SUBJECT: REVIEW/CONCURRENCE OF WNP-2 SSER

Attached is a draft of the WNP-2 SSER for your comment and concurrence.
All comments/concurrence must be received by the project manager by C.O.B.
Thursday, July 29, 1982.

APPENDIX F DOCUMENTATION OF THE STAFF RATIONALE OF ACCEPTING
THE PLANT-UNIQUE POOL DYNAMIC LOADS

Figure 13.1 Washington Public Power Supply System

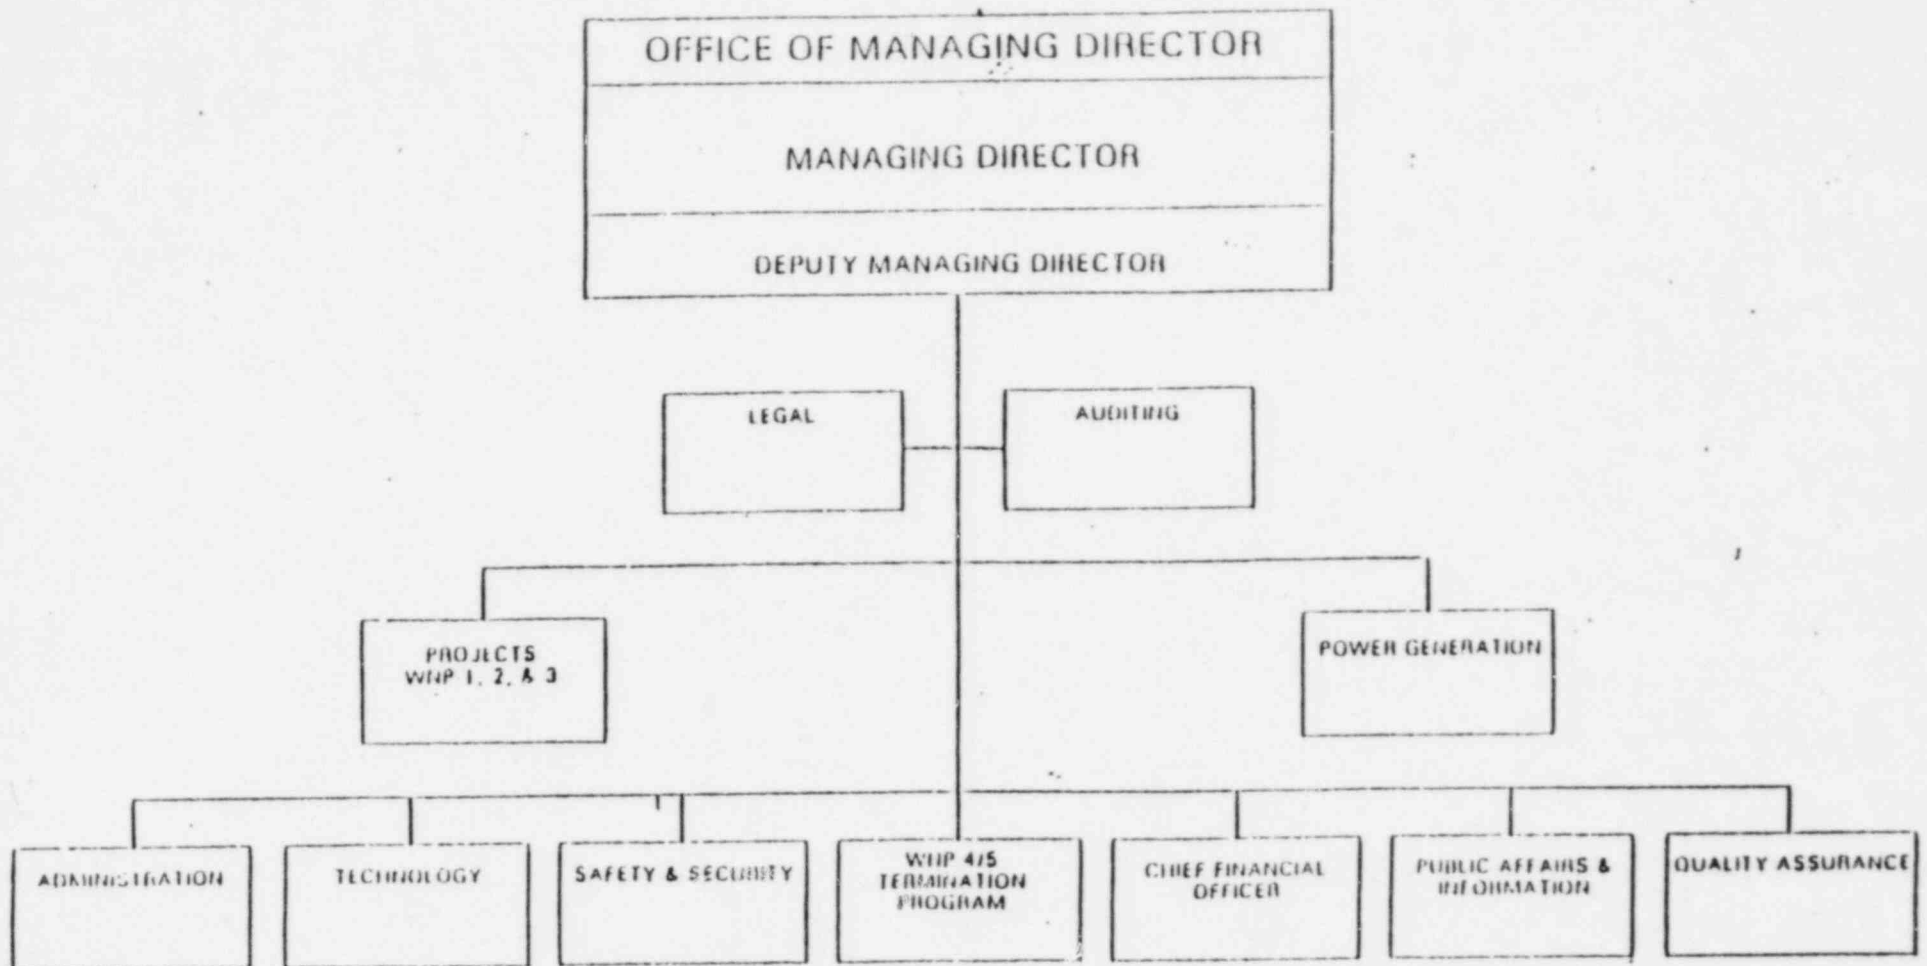
The staff concludes that these changes meet the acceptance criteria of SRP 13.1.1 (NUREG-0800). Figure 13.1 has been revised to reflect the corporate reorganization.

Figure 8. Relation of percent of total fault length ruptured (P_r) to total fault length (L) for strike-slip faults for 9 data points from worldwide data: $P_r = 15.76 + 0.012 \times L$ (in km), from Slemmons (1983, in press).

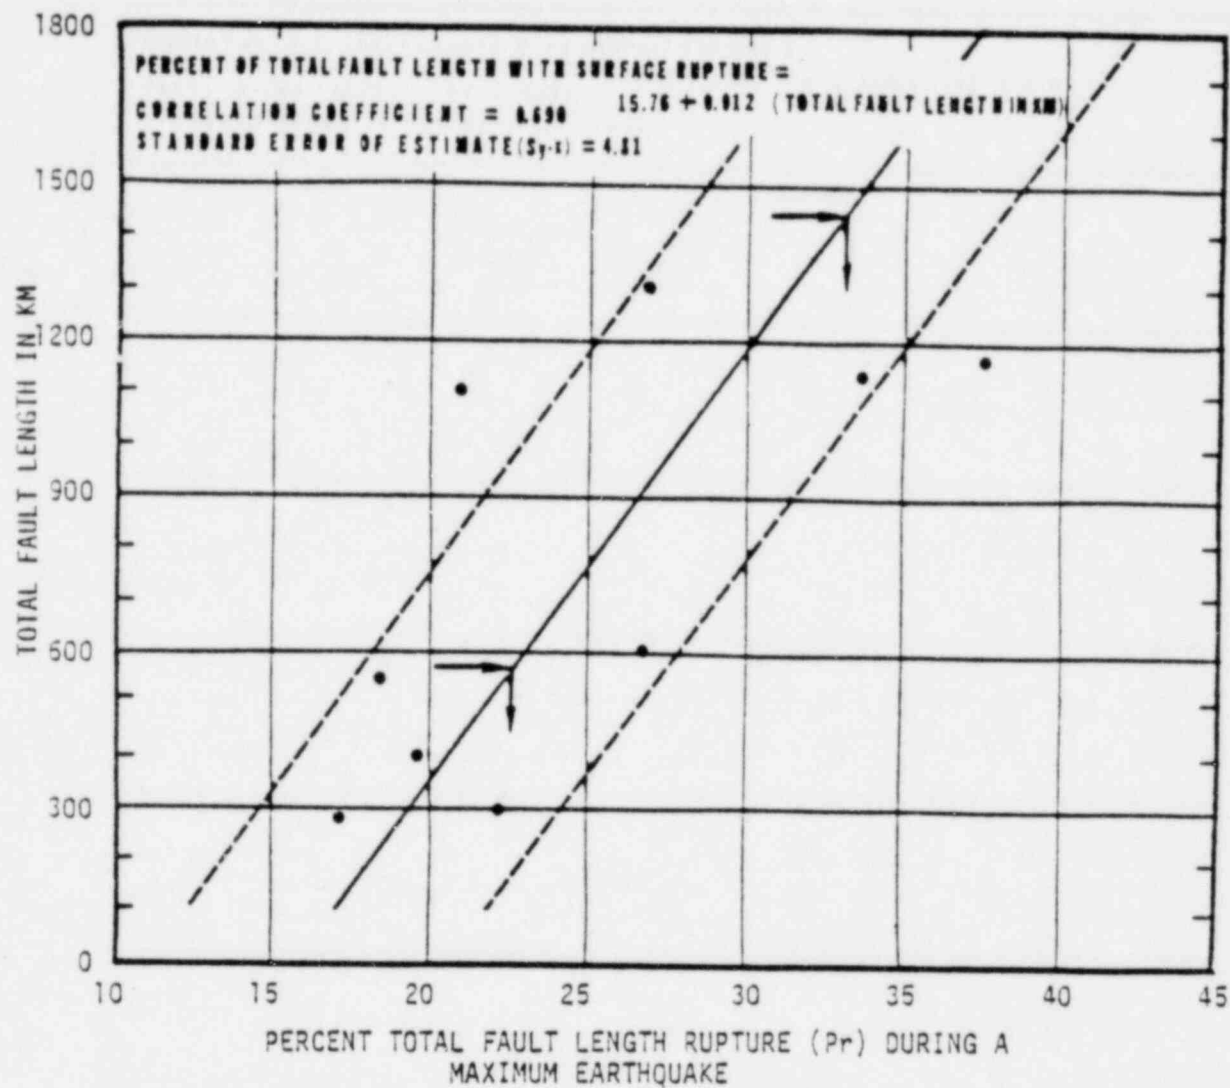
The data of Table 5 and Figure 8 suggest that major, strike-slip movement involves an average segmentation of less than 20 percent of the entire fault length for strike-slip faults of less than 300 km length, to almost 40 percent of the total fault length for faults of about 1300 km length. This agrees well with an earlier data compilation (Slemmons, 1980). Less is known for faults of minor character, for lengths of less than 300 km, and for faults of normal-slip, reverse-slip or combination-slip character. The application of these segmentation methods is uncertain for the RAW structure of about 120 km length.

Figure 9. Relation of earthquake magnitude (M_s) to total fault length L (in km) for strike-slip faults. Regression for 9 data points: $M_s = 6.618 + 0.0012 \times L$ (in km) from Slemmons (1983, in press).

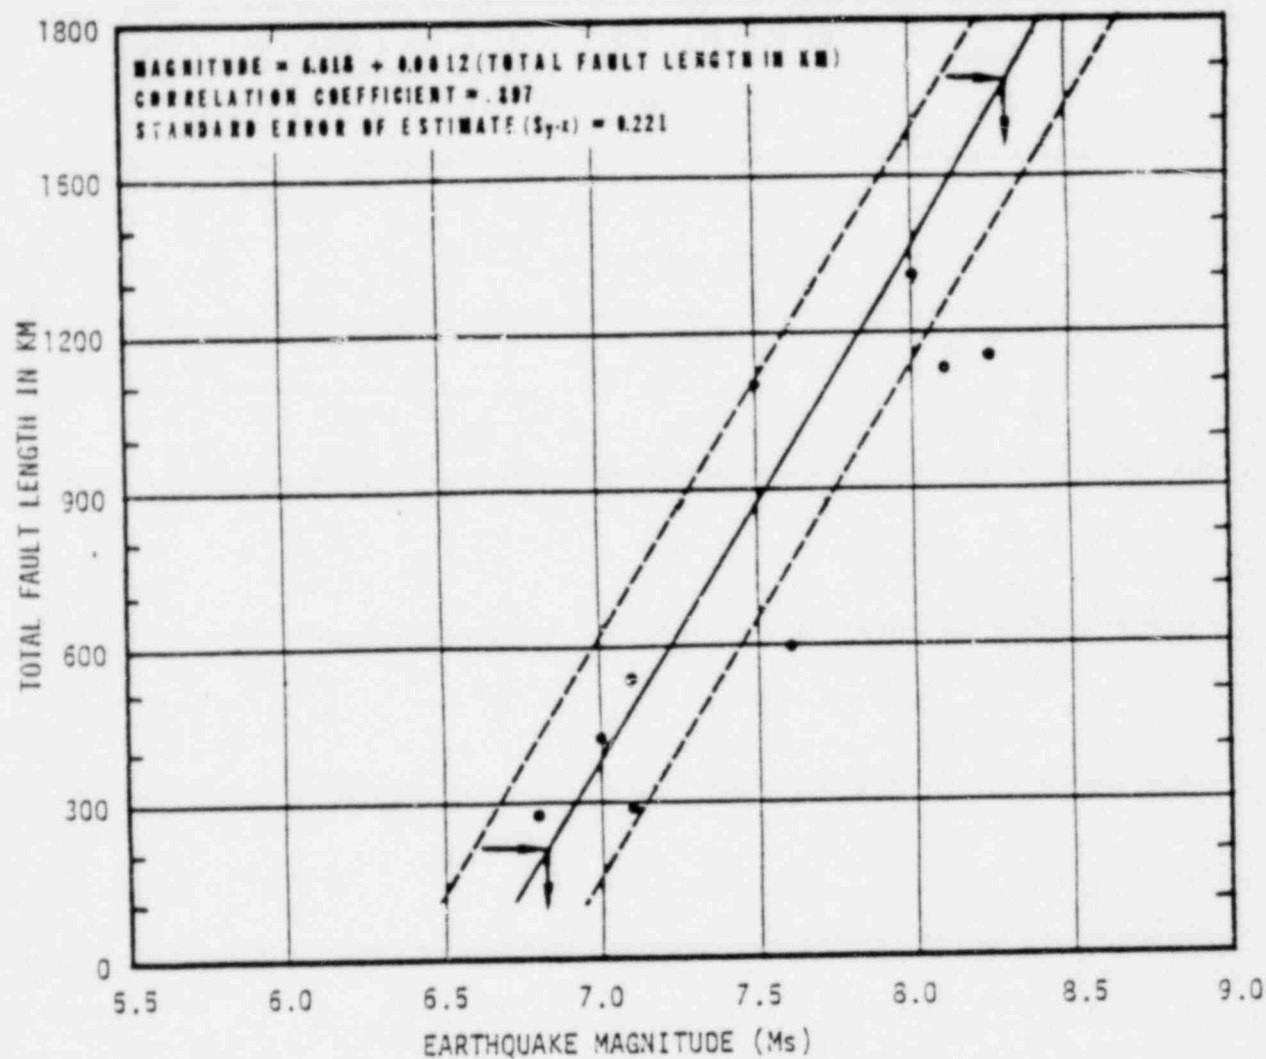
The data of Slemmons (1982, 1983), Slemmons and Chung (1982), and Slemmons and others (1982) for the 9 strike-slip faults with earthquakes of above 6 magnitude, as revised in Table 5 and Figure 9, suggest a relationship between earthquake magnitude and the total fault length of strike-slip faults. The data are for faults with slip rates that are generally measured at more than 1 mm/yr, and with total lengths greater than 280 km. The application to other fault-types, to faults with total lengths less than about 100 to 200 km, or to lower slip rates should be used with caution, but may be applicable in the Columbia Plateau.

The question of the use of the full segment length, or a fractional segment length when determining magnitude values has not been resolved. The use of full segment lengths in formulations of Table 5 and Figure 9 is more conservative, but there is no known rationale for the assignment of a potential full segment rupture length, a half segment length, or some smaller fractional length. The use of one-half length is customary for analyses, but there is no presently available justification for this use. More than a full segment length appears to have been involved during the 1857 right-slip event on the San Andreas, with inconsistent amounts of displacement noted on several sections of the San Andreas and the possible inducing of the earthquake by prior movement near Parkfield and/or Cholame by a lower magnitude earthquake and movement on a different segment. This makes the use of segments a difficult process for the San Andreas fault.

Figure 10. Relation of average geologic slip rate to earthquake magnitude (M_s) for strike-slip faults with a comparison of SEL, MEL, and HEL lines (after Woodward-Clyde Consultants, 1980).

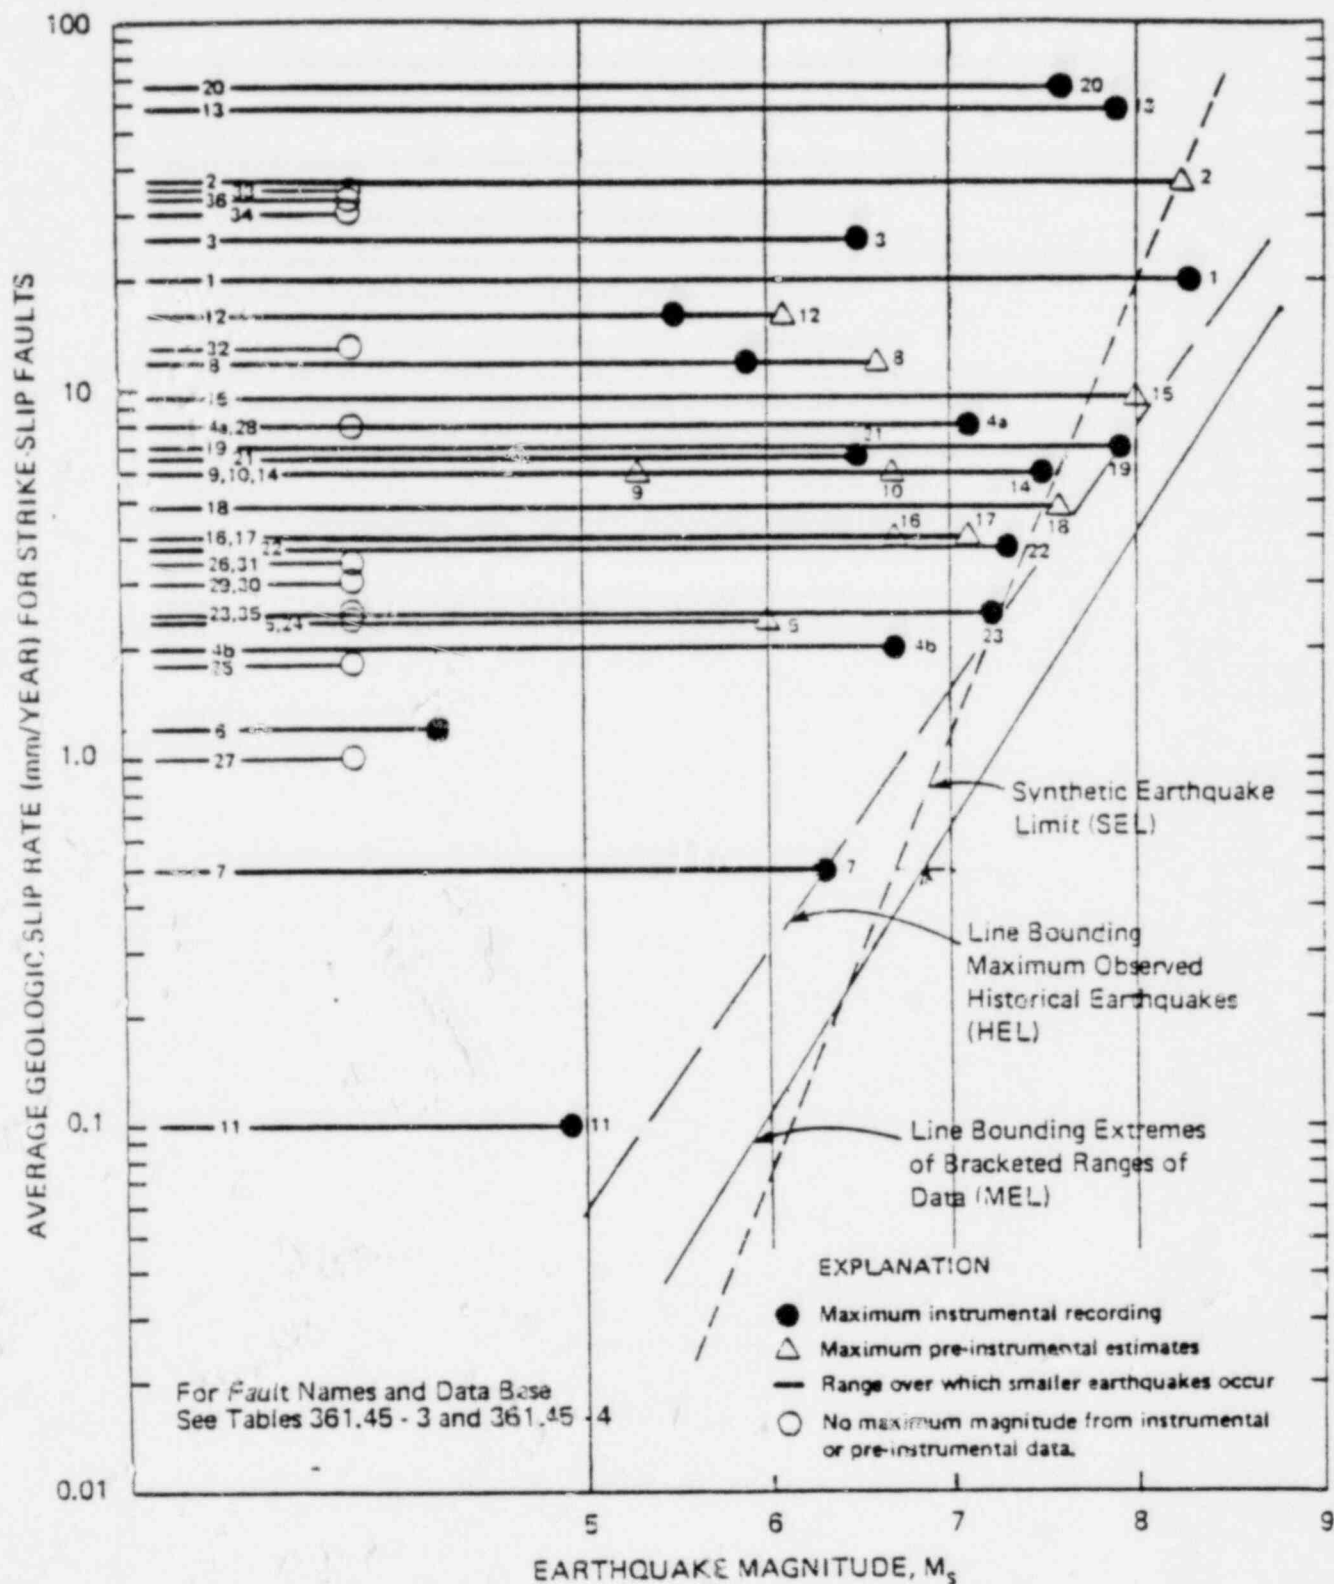
This method originally was proposed by Woodward-Clyde Consultants for the San Onofre docket in 1979 and was refined by the WCC (1980a) response to question 361.38 (fig. 10). No data are used for slip rates less than 0.1 mm/yr and only two data points are available for slip rates less than 1 mm/yr, but the method may be applicable to the low-slip rate structures in the Columbia Plateau. The data may be checked by use of Table 1 and Figure 11.
